DELEGATED OFFICER REPORT

**WOKINGHAM
BOROUGH COUNCIL**

Application Number:	260736
Site Address:	Land Adjacent To Highfield Park Eversley Road Arborfield RG2 4PP
Expiry Date:	8 June 2026
Site Visit Date:	24 March 2026
Proposal: Full application for the proposed change of use of land for the stationing of 1 no. static caravan for occupation by Gypsies / Travellers with associated access.

Drawing 2509(p)133a has been submitted which sets out the proposed access arrangements. The proposed access comprises of a bell mouth junction with 6m radii each side which forms access to a 10m strip of tarmac with a width of 5.5m with 2m either side.

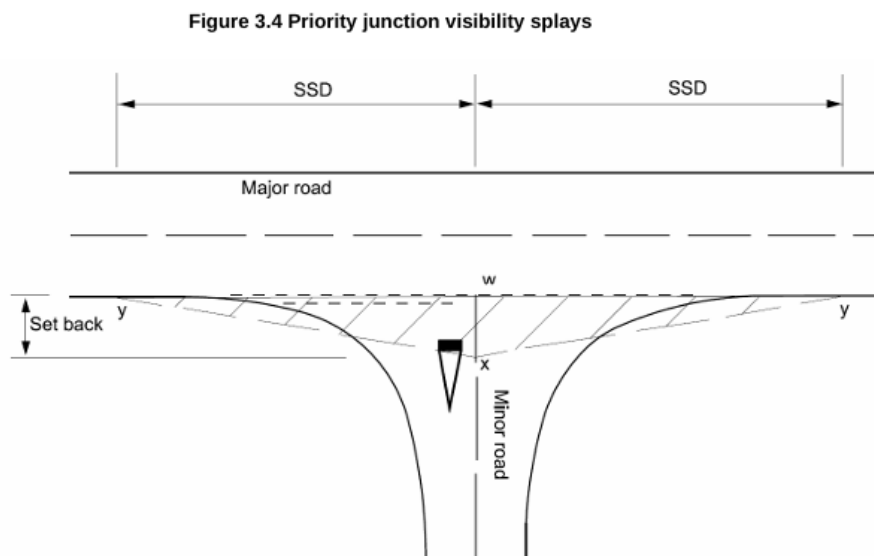
As the proposed access is situated near a street lighting column, a telegraph pole and what appears to be a utilities box, the WBC Streetworks / Highway Assets teams may need to be consulted by the applicant.

A Stage 1 Road Safety Audit report is required for a new access onto an A-road which is to be submitted by the applicant. It should be noted that speed survey results are required to be reported. Depending on the AADT, further highway works may be required, such as implementing a ghost island, in line with DMRB CD123.

The visibility splays of 2.4m x 120m (for a 40mph road in line with DMRB) have been shown in Drawing 2509(p)132a. This section of the A327 is subject to a 50mph speed restriction therefore 2.4m x 160m visibility splays are to be shown on a revised plan. Alternatively, this can be assessed based on the speed limits of the 85-percentile speed provided by the applicant submitting full speed survey results for the road where the access is located. This is to set out the Annual Average Daily Traffic (AADT) flows.

The proposed plans do not highlight the street lighting column, telephone pole or road sign located on the A327 just to the north-east of the proposed access. To add, the vegetation to be removed on the plan appears much less than the vegetation present along the northwestern edge of Eversley Road. The applicant is to demonstrate that visibility splays to be provided in accordance with Figure 3.1 of DMRB CD 109, with no obstruction to the required sightlines between a driver's eye height of 1.05 m and an object height of 0.26 m over the full stopping sight distance. Within the visibility splay, the sightlines shall be across land within the applicant's control or highway land and shall be clear of obstructions to visibility between 0.6m and 2.0m in height.

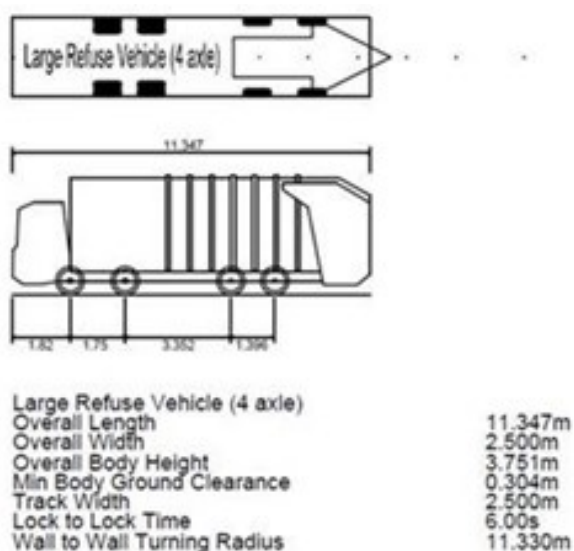
Parking is to be provided in line with WBC Parking Standards, and the minimum dimensions of each parking space is 2.5m x 5m. Drawing 2509(p)135a shows the proposed floor plans of the static caravan which is to have three habitable rooms.

For a proposed dwelling of this scale in a 'village' location, two parking spaces are required. The proposed plans show 2 parking spaces of suitable dimensions, which is welcomed. This is an acceptable parking provision in line with WBC's Parking Standards.

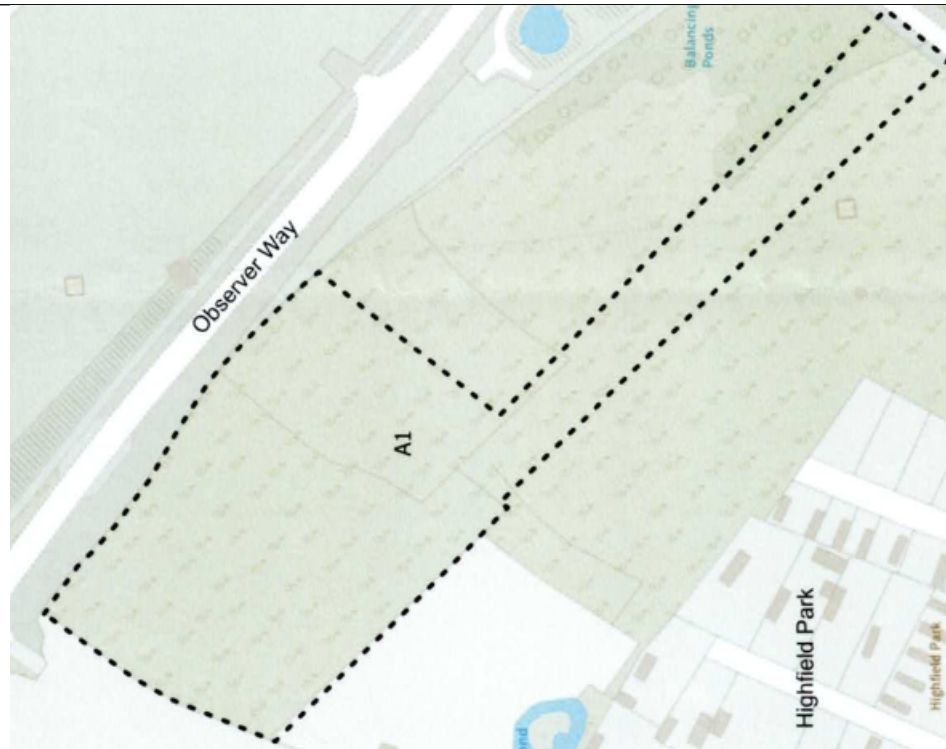
The below plan indicates the areas of flood risk which comprises some of the caravan site and nearly the entire access road:

Whilst a Flood Risk Assessment has been submitted, it is not considered to meet the requirements of the Planning Practice Guidance and does not provide sufficient site-specific information to demonstrate that the development would be safe for its lifetime, would not increase flood risk elsewhere, and would appropriately manage surface water flood risk. In particular, the assessment lacks adequate evidence regarding flood levels, climate change impacts, safe access and egress, and the feasibility of the proposed drainage measures. Consequently, the Local Planning Authority is unable to conclude that the development would be safe from a flood risk perspective, nor that sufficient information has been provided to assess the appropriateness and proportionality of the Sequential Test.

Planning permission F/2009/2110:

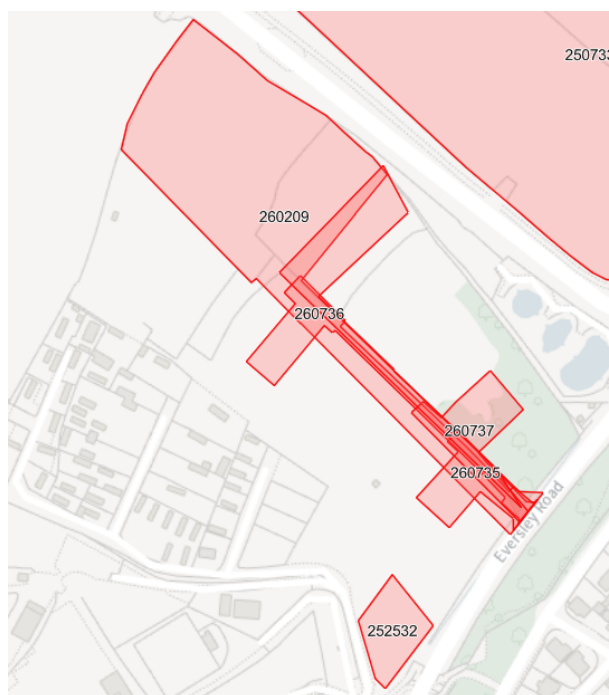
Subsequent investigations have clarified that the access approved under F/2009/2110 is not located in the same position as the access now formed on site. This is confirmed by comparison of the approved plans with the current site layout, including on-site measurements. The red line plan accompanying the 2009 permission clearly relates to a different part of the frontage.

There is no lawful access on the site and therefore accordingly the access must be assessed as a new access onto Eversley Road and the 2009 planning permission has no bearing on this application.
